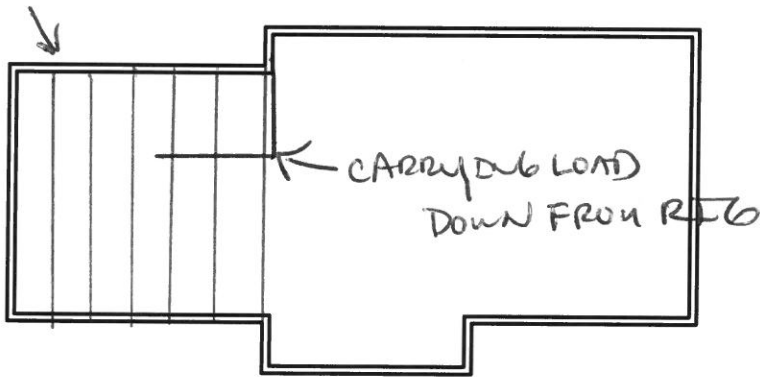
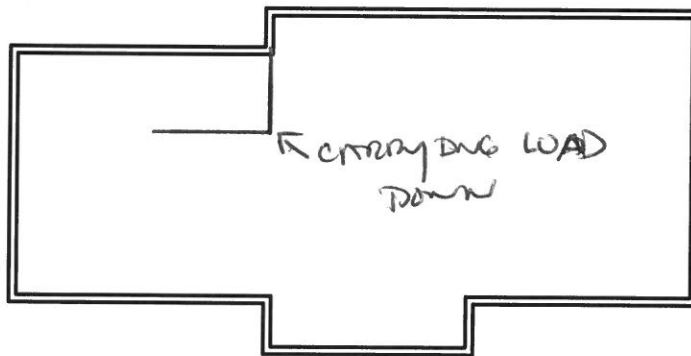
SISTEROOD FLOOR DIST DUE TO SPLITTING

ALL WORK WAS INSPECTED BY ANDREW JONES AT STRUCTURAL INTEGRITY + RECOMMENDED
